EXISTING L1 & L2
PLATE 7 DETAIL

NEW L1 & L2
PLATE 7 DETAIL

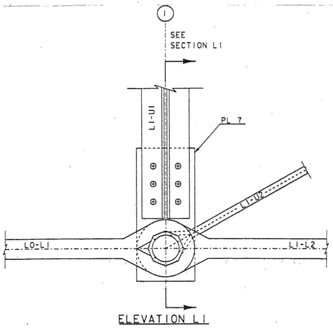
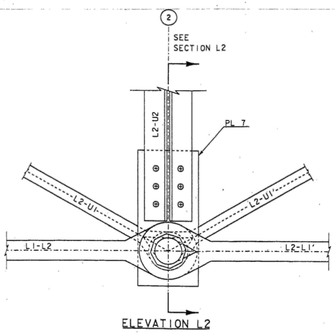
PROVIDE ONE NEW PLATE, THREE TOTAL, AT EACH VERTICAL CONNECTION ON THE SOUTH SIDE OF THE TRUSS FOR ATTACHING THE SEWER LINE.

PL ⅜x6½x1'-5⅛"

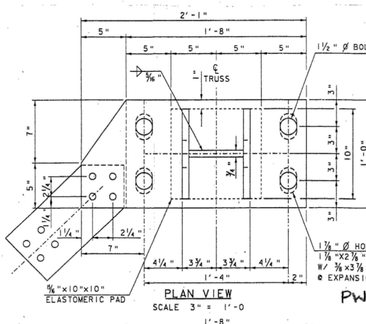
The replacement of members EP1, U1-U2, U2-U1', and EP1' necessitates different details than shown on this sheet. See Sheets 10-13 (1/4-4/4) for modifications.
